DATE: July 2, 2021
TO: All Bidders
FROM: Jo Nell, Purchasing Specialist
SUBJECT: Addendum 3 – Bid 619 Moorpark College Tiger Enclosure

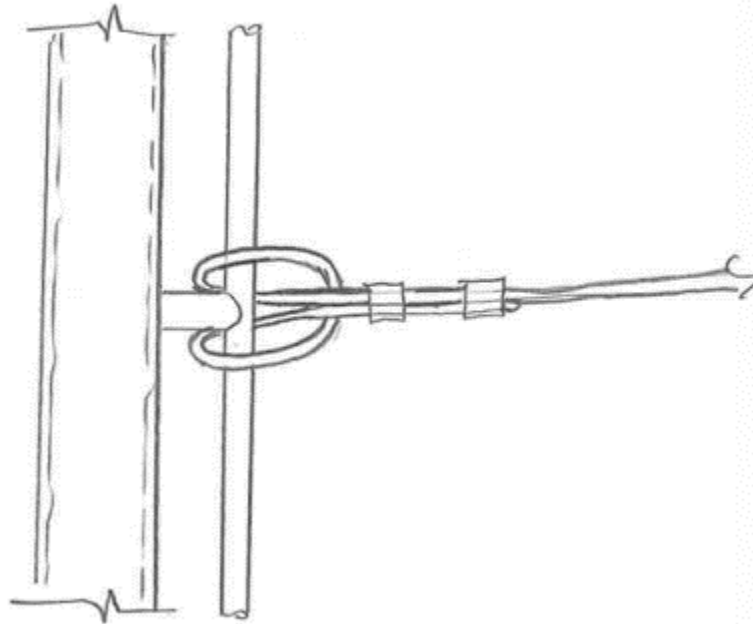
15. Is there a sag schedule for any of the cables / is there any desired amount of sag for any of the cables required in both enclosure 1 & 2? (Roof cables or the support cables)

Answer: No set sag schedule. For structural, we were anticipating the maximum sag around:

- Roof cable sag of cable length/60 (comes out to 4" sag in 20' and 8" sag in 40')
- Fence cable sag of cable length/120 (comes out to 1.5" sag in 15')
